Vogtle

units 3&4 Nuclear Development

Vogtle Units 3&4 Nuclear Island Basemat Design Increase to Specified Compressive Strength of Concrete

July 19, 2012

Vogtle Basemat Design

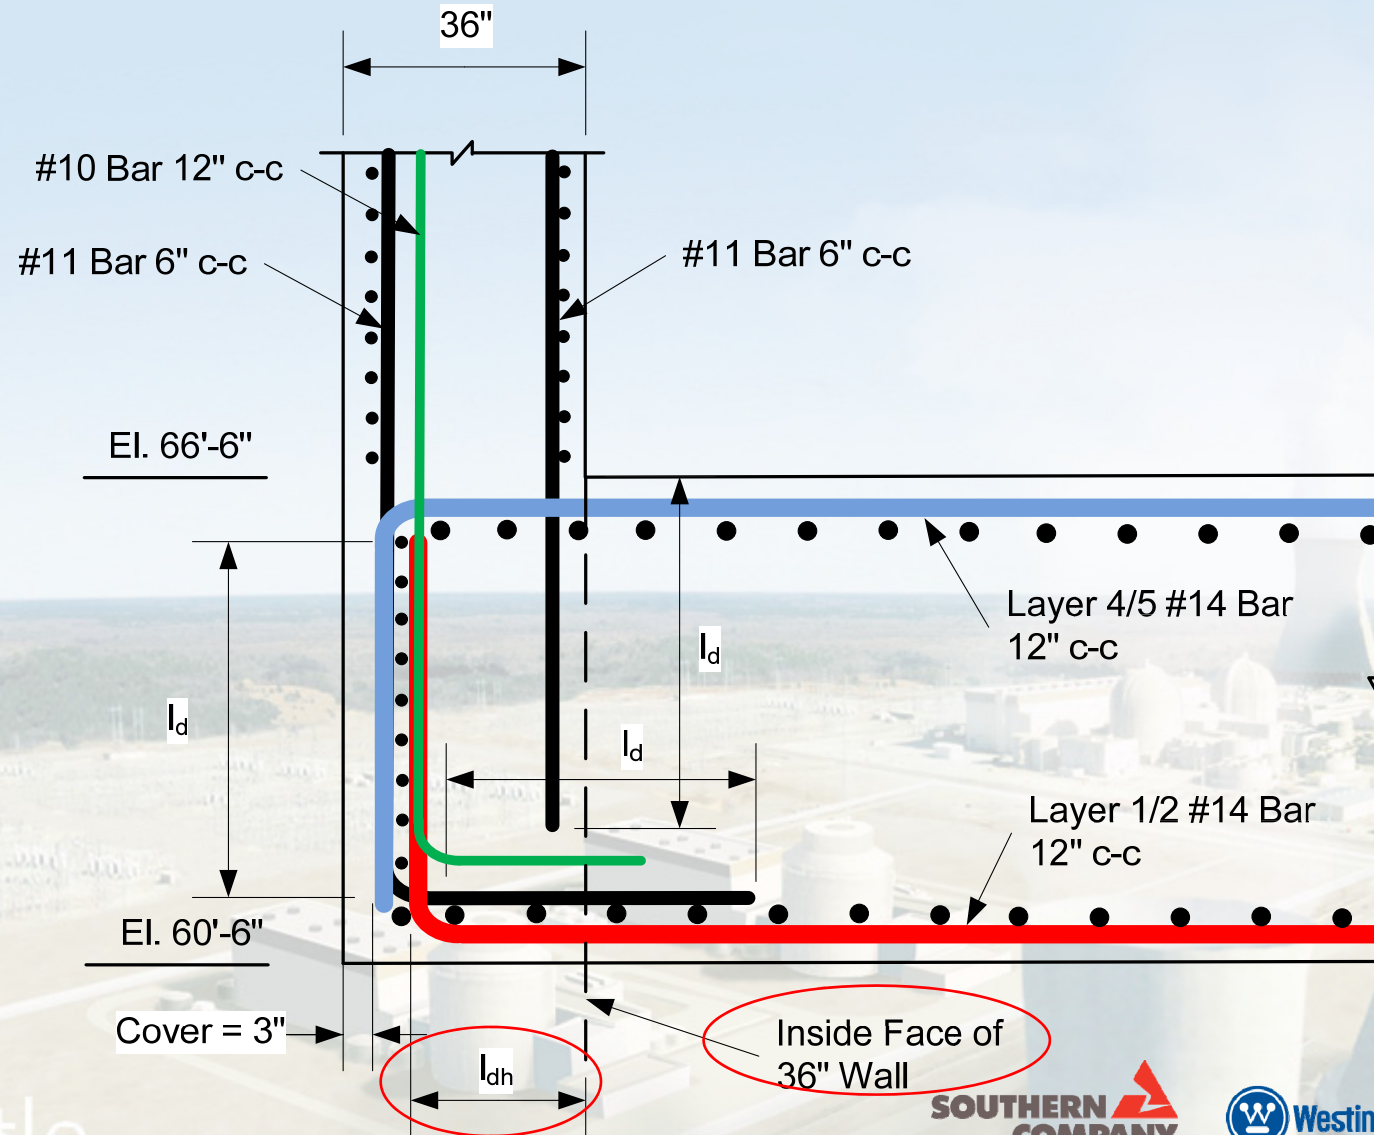
- The required standard hook development length l_{dh} is specified in ACI 349-01 12.5.2
 - The two variables are the nominal rebar diameter and the specified compressive strength of concrete
 - Changing the specified compressive strength of concrete reduces the required development length for a given bar diameter
- The solution is to increase the specified concrete compressive strength of the basemat concrete from 4000 psi to 5000 psi
- The required l_{dh} for Layers 1 and 2 will then be developed within the inside face of the 36" wall

Figure 3H.5-3

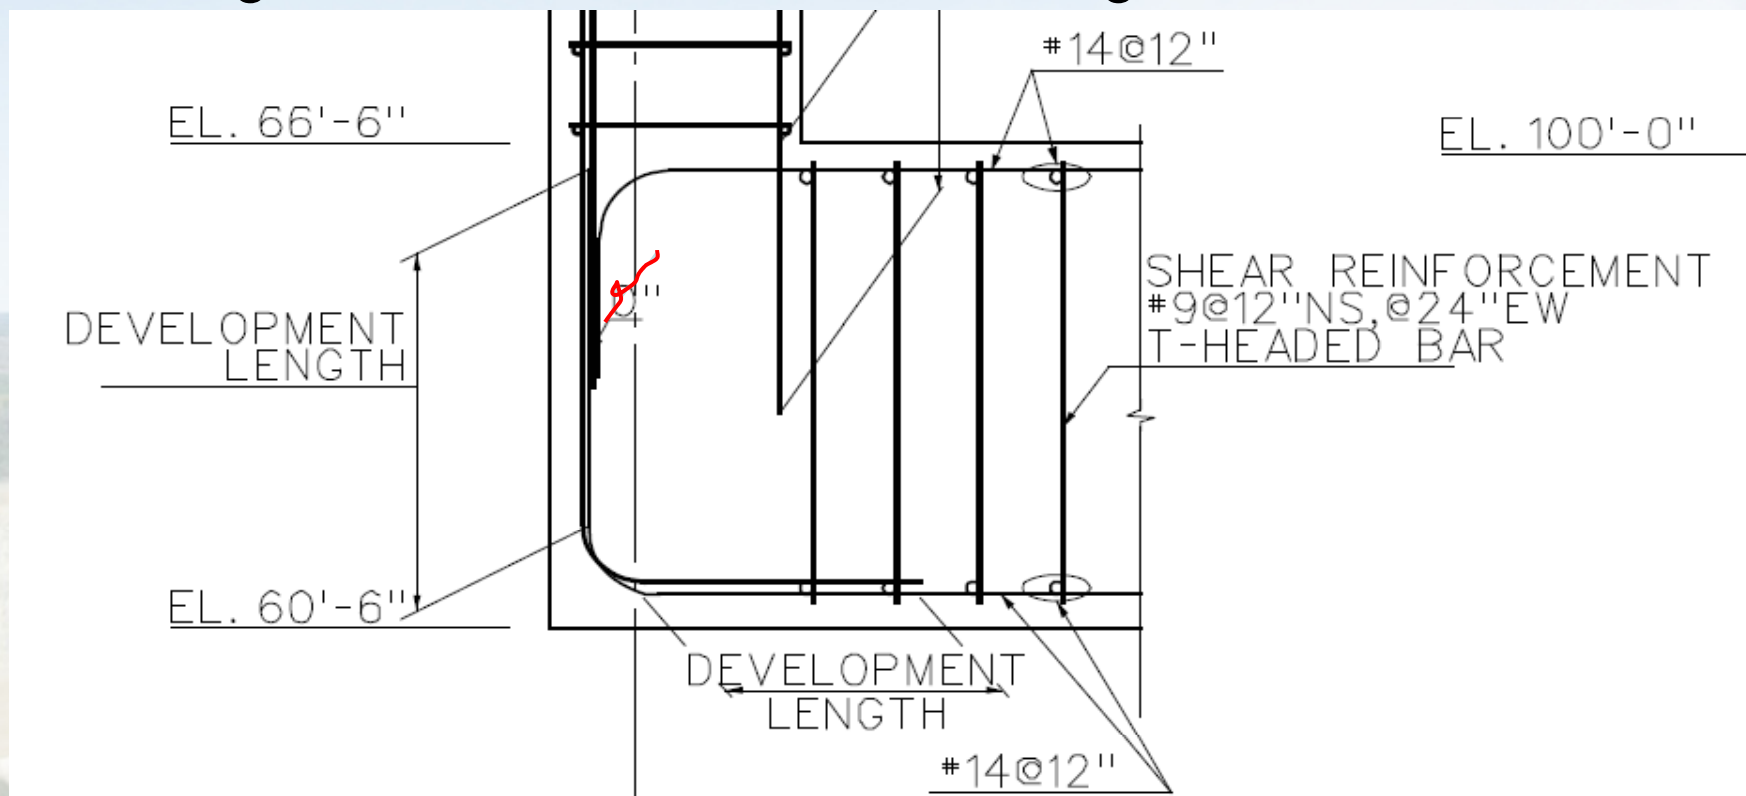
- The basemat perimeter detail is illustrated in UFSAR Figure 3H.5-3
- The required standard hook development length of Layer 1 and 2 rebar is 32.1" for 4000 psi concrete
- The available Layer 1 and 2 standard hook development length is 29.5" due to rebar placement constraints caused by the MSE wall

- With the use of 5000 psi concrete the reinforcement design is in conformance with Figure 3H.5-3

Sensitivity study of 5000 psi concrete basemat

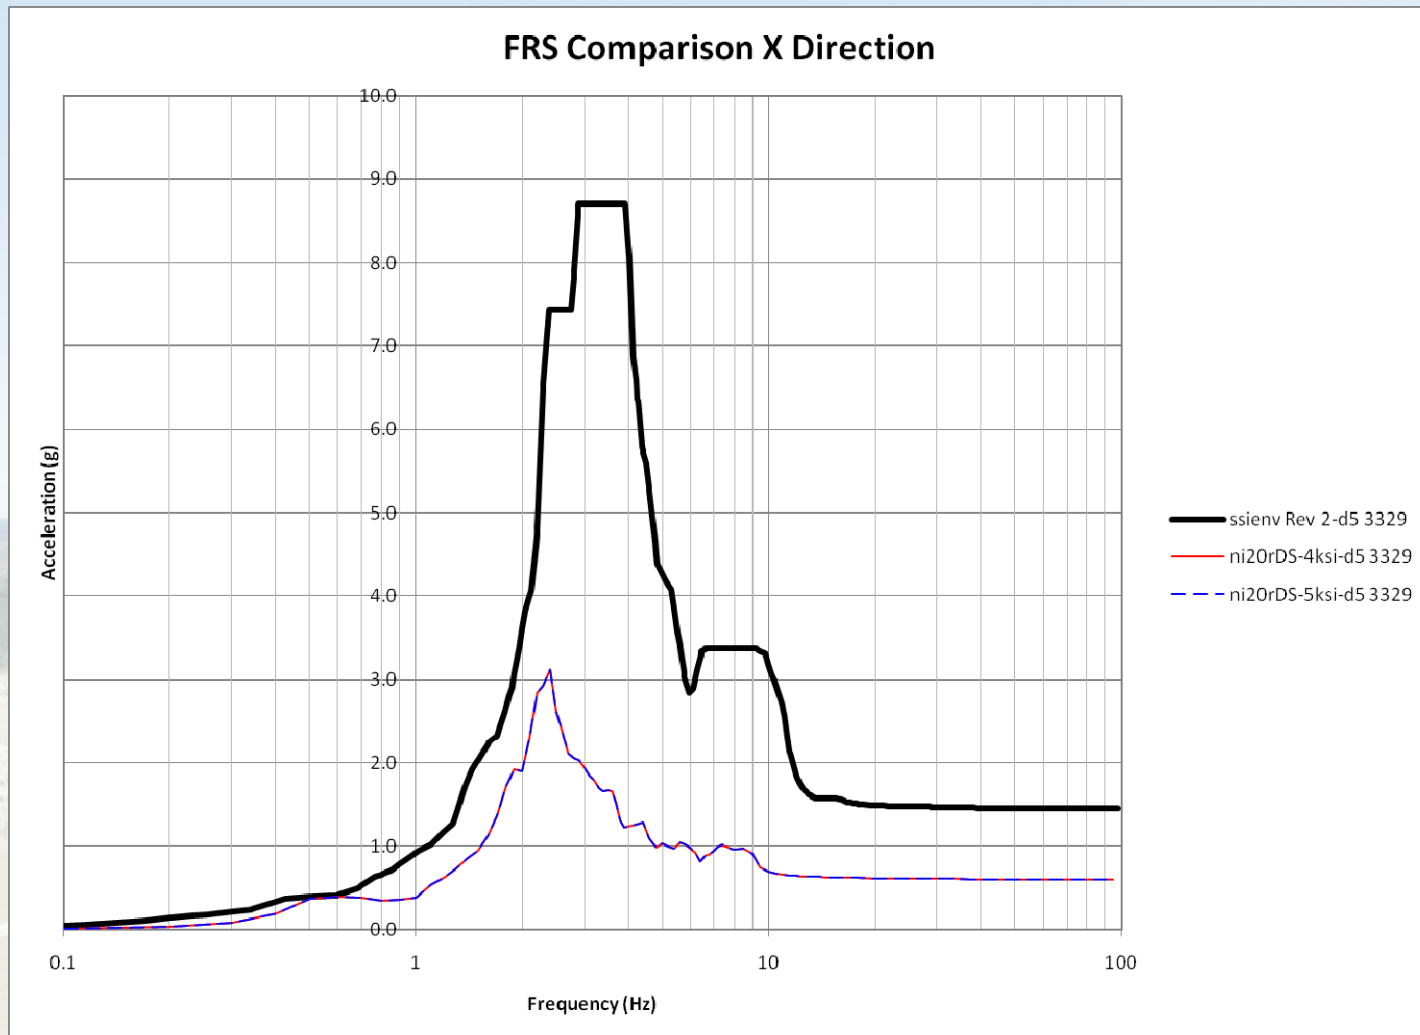
- A sensitivity study was performed using both 4000 psi and 5000 psi concrete for the basemat in a soil-structure interaction analysis.
- The SASSI ni20 model was modified by changing the modulus of elasticity of the basemat shell elements to reflect the 5000 psi concrete, including Vogtle best estimate soil profile and seismic input.
- The Floor Response spectra for all six key locations was compared. There was no change in FRS. There was no change in the maximum accelerations.
- Since there are no instances where the generic maximum accelerations are exceeded, there is no effect on the generic analyses
- Since there is no change in the maximum accelerations, there is no effect on the seismic design margins.

Comparison of SASSI basemat stresses

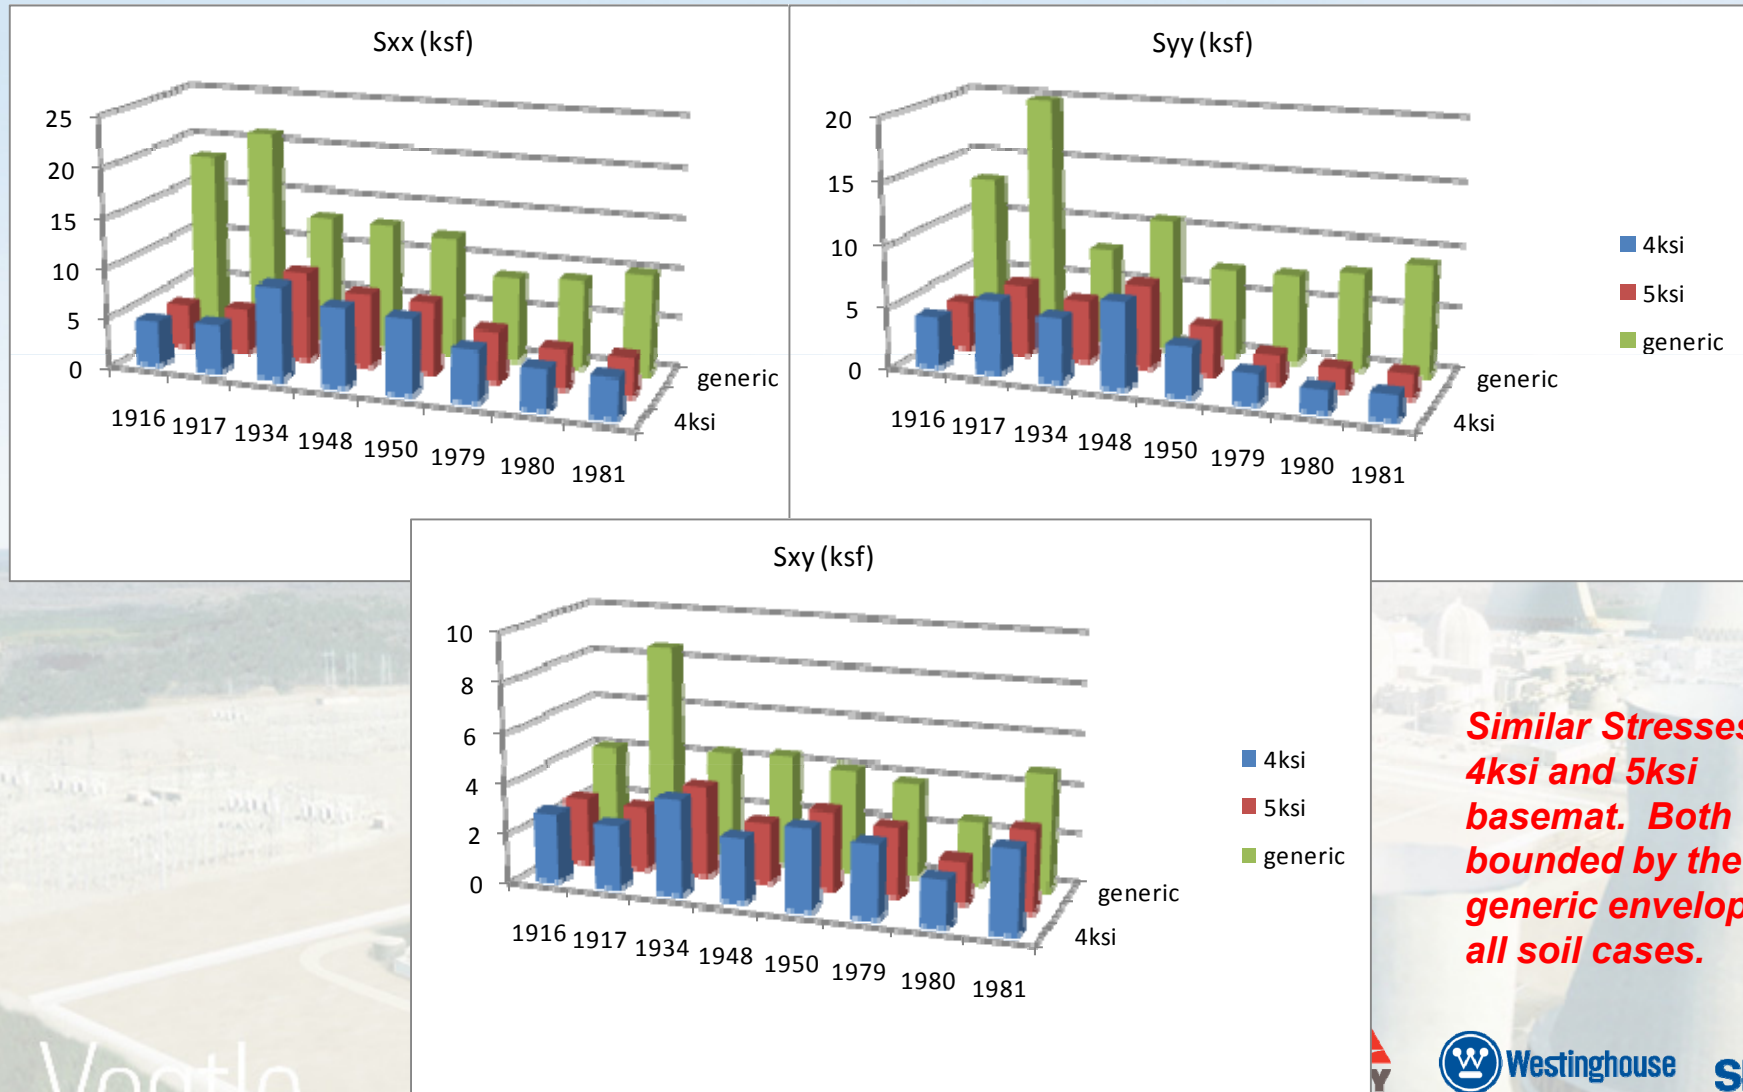
Similar Stresses for 4ksi and 5ksi basemat. Both are bounded by the generic envelope of all soil cases.
